**66321D-05**

**S E R V I C E N O T E**

66321D

**Reliability Improvement of Instrument**

**CORRECT J207 PLACEMENT** – alignment to within  $< 0.3\text{mm}$

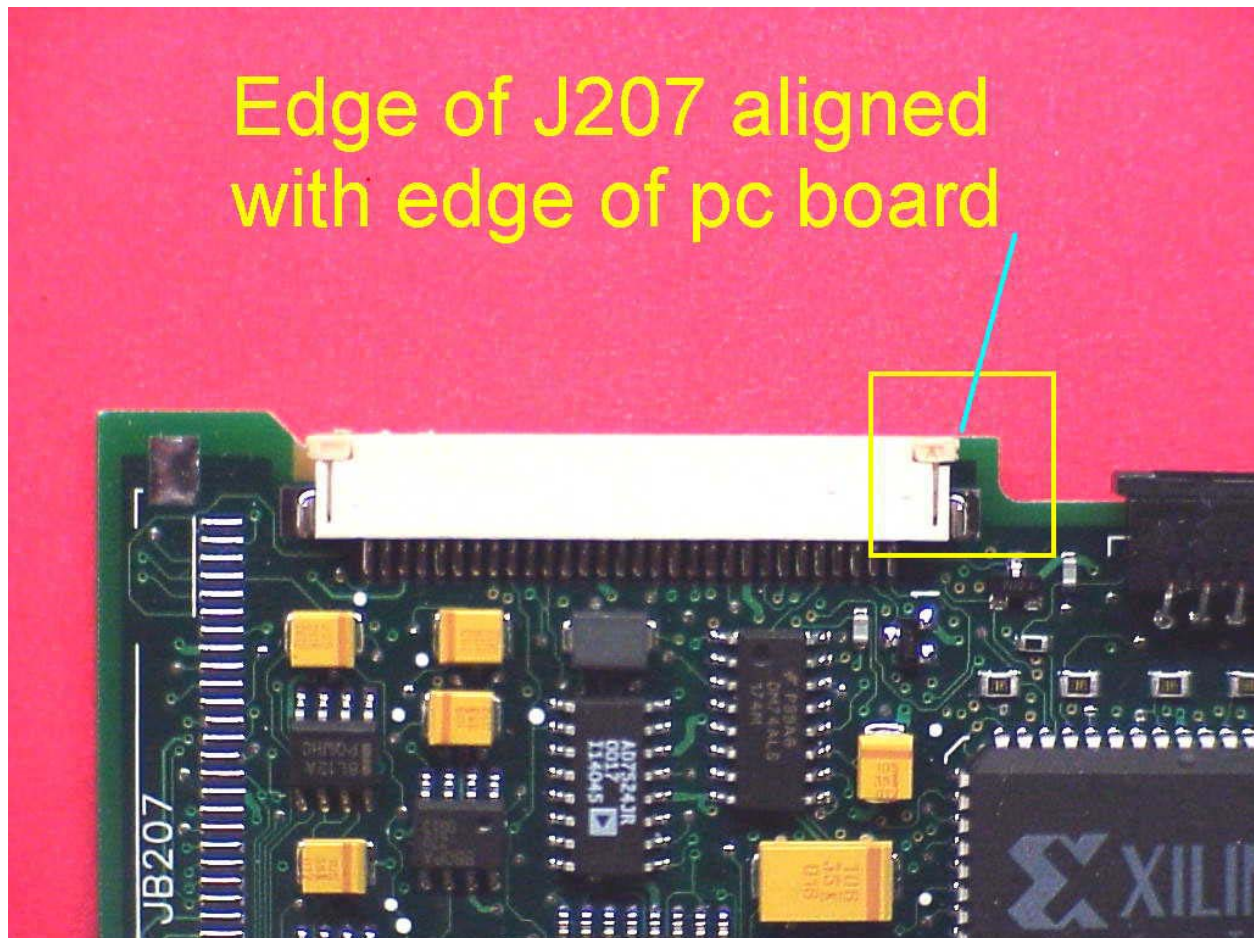
Latent product failure due to misplaced connector J207 on SMT assembly 5064-0018 (GPIB/RS232 interface). Misplacement of J207 could lead to inadvertent contact/shorting of exposed feed-throughs on SMT board. Ultimately, resulting in over-stress of components of damage to SMT board components. Resulting contact could degrade useful life of instrument.

Picture shows connector aligned to edge of SMT board to within  $< 0.1\text{mm}$

- 1) Compare placement of J207 to attached photos. Instruments with a “misplaced” J207 should be returned to Agilent for warranty repair.
- 2) Instruments returned to the Service Center for routine calibration should be inspected for this potential defect. Defects should be addressed using Agilent’s unit exchange process with costs being charged to warranty.
- 3) The factory has modified production documentation to include visual inspection and specific electrical testing for this potential short.
- 4) Factory is maintaining feedback to SMT board supplier regarding quality of assembly.

**INCORRECT J207 PLACEMENT** – misaligned by  $> 0.3\text{mm}$

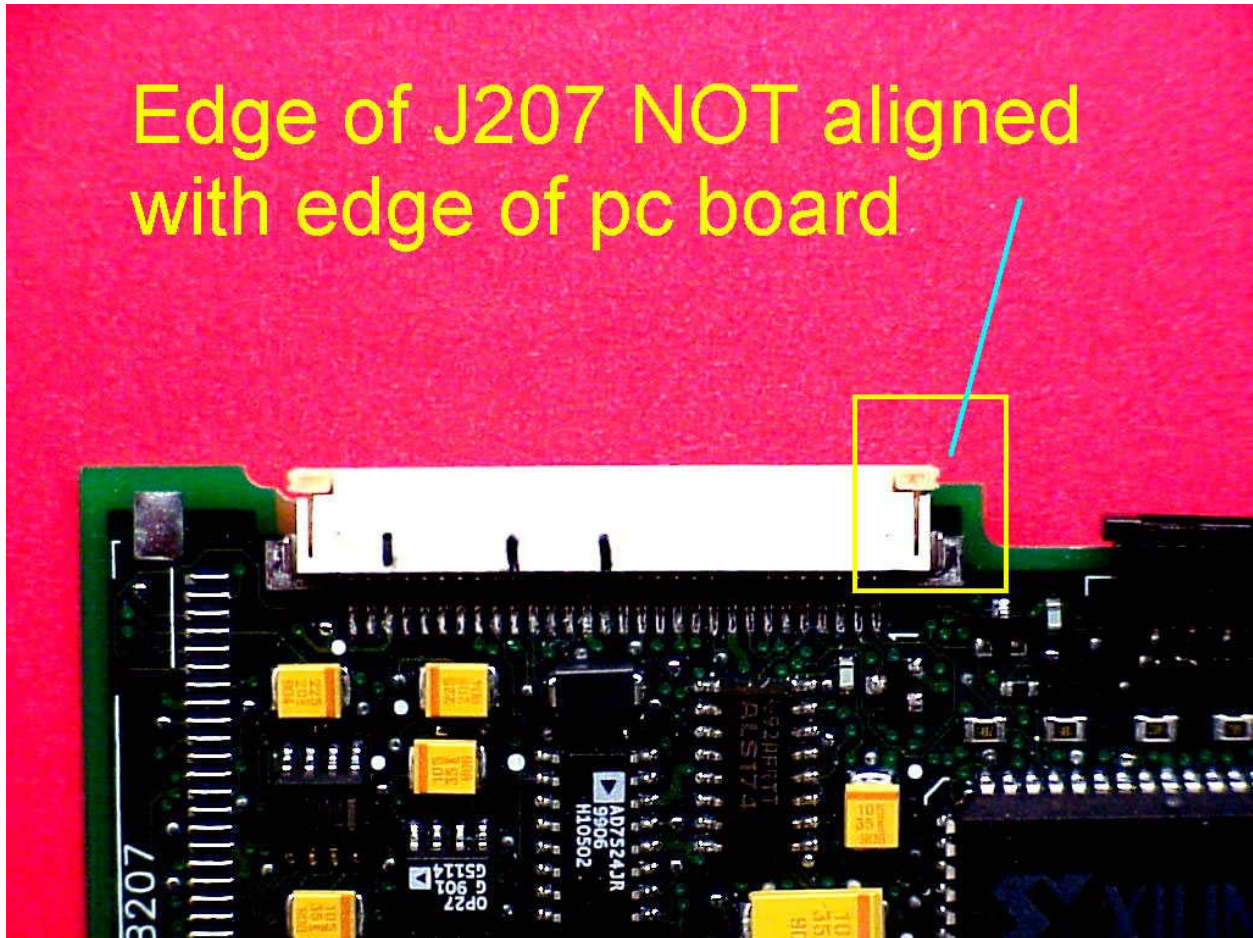
Picture shows connector extending past edge of SMT board by  $>1.2\text{mm}$
